**AIRWORTHINESS DIRECTIVE**

No. 2026-FATA-010144R-01

Applicability – ANSAT helicopters (ANSAT, ANSAT-GC models) and their modifications  
Designer's State - RUSSIAN FEDERATION

**TECHNICAL DECISION No. 1/144-2025-KB3**  
on continued airworthiness of the ANSAT helicopters (ANSAT, ANSAT-GC models)  
**Revision 2**

**Figure 201 – General view of tail shaft XB-23 230-1526-000**

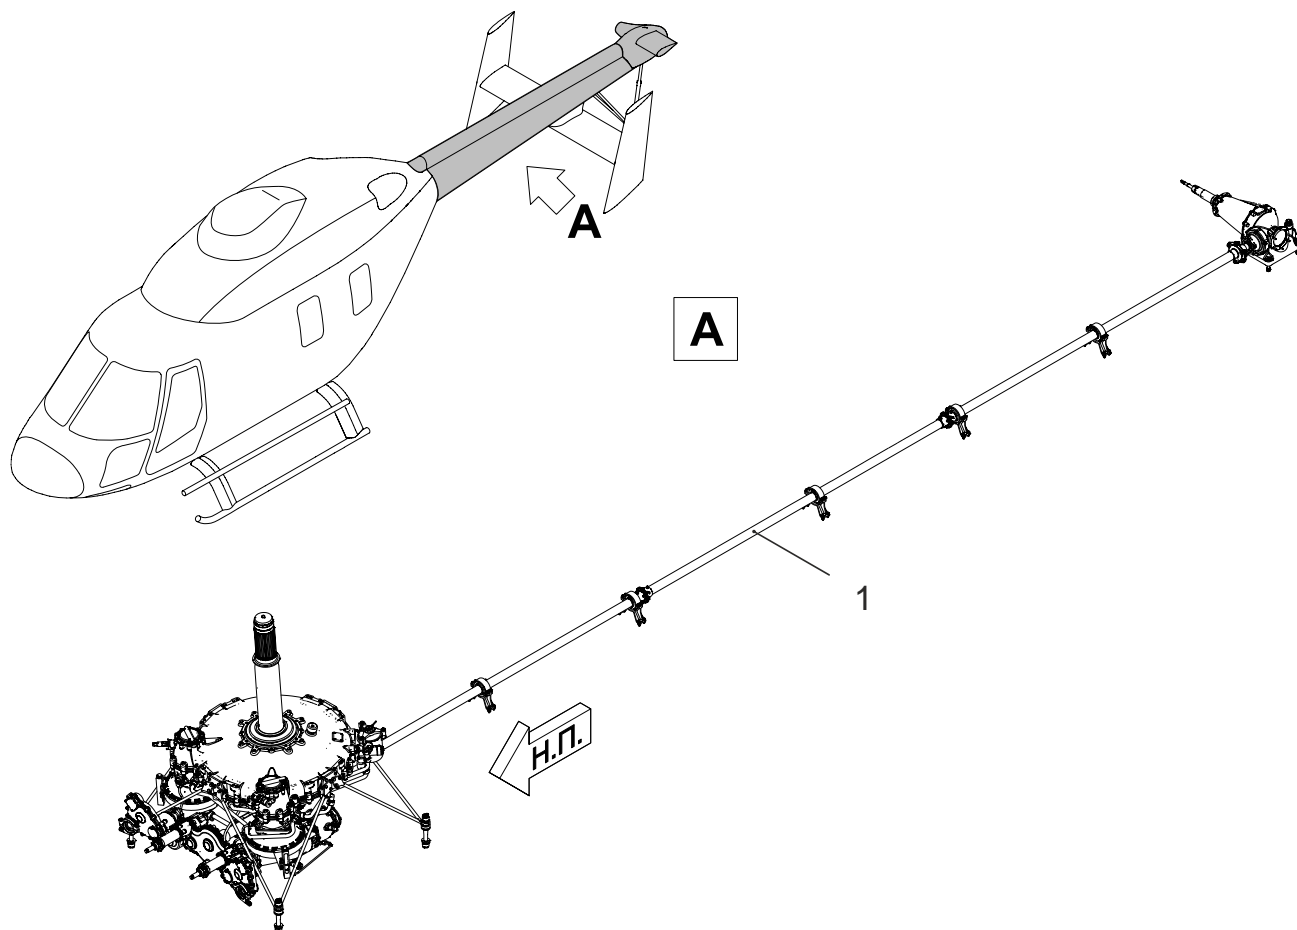
| <b>Temporary task card 065.10.00j</b>  |  |                      |
|--|--|----------------------|
| <ol style="list-style-type: none"> <li>1 Install the stepladder in the area of the fuselage junction with the tail boom.</li> <li>2 Remove the rear fairing and access door above the tail gearbox.</li> <li>3 Open the tail shaft cover and clean the tail shaft from dirt and dust.</li> <li>4 Inspect visually the outer surface of the tail shaft (see figure 201).<br/> Make sure there is no twisting (along the sight line) or mechanical damages.</li> <br/> <p>Traces of corrosion, as well as blistering (swelling) of paint coating is not allowed on the outer surface of the tail shaft (see figure 202).</p> </ol> | <p>See page 101/102 of section 065.10.00 of MM - “Troubleshooting”.</p><br><p>Perform additional inspection of the outer surface of the tail shaft for cracks and corrosion damages using IJM-15B method with the participation of specialists of JSC “Reductor-PM”, with the issue of the Inspection report (Appendix No. 2).</p> |                      |

**Figure 202 – Examples of defects**

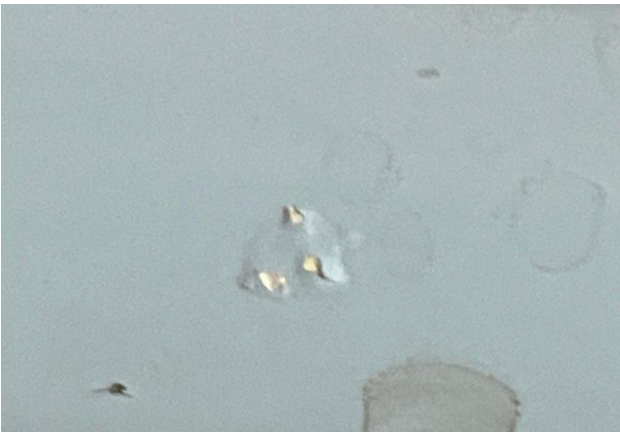
In case of detection of corrosion traces on the outer surface of XB-23 tail shaft 230-1526-000, as well as blistering (swelling) of the paint coating (see figure 202) – perform an additional inspection of the outer surface of the tail shaft for cracks and corrosion damages using IJM-15B method with the participation of the specialists of JSC “Reductor-PM”. Inspection results must be included in the Inspection report (Appendix 2).

1.4 In addition to the requirements stated in the task card 065.10.00a “Visual inspection of the transmission tail shaft” of the helicopter Maintenance manual, limitation shall be introduced in order to prevent the presence of corrosion traces, as well as blisters (swelling) of the paint coating (see Figure 202) on the outer surface of the XB-23 tail shaft.

1.2 XB-23 tail shafts 230-1526-000 with the defects detected during inspections using IJM-15B method must be removed from operation and sent for repair.

In case of detection of defects, perform an additional inspection of the tail shaft outer surface for cracks and corrosion damages using ЦМ-15В method with the participation of specialists of JSC “Reductor-PM” (inspection results must be included in the Inspection report according to the Appendix No. 2), in case of detection of defects – tail shaft must be removed from operation and sent for repair.
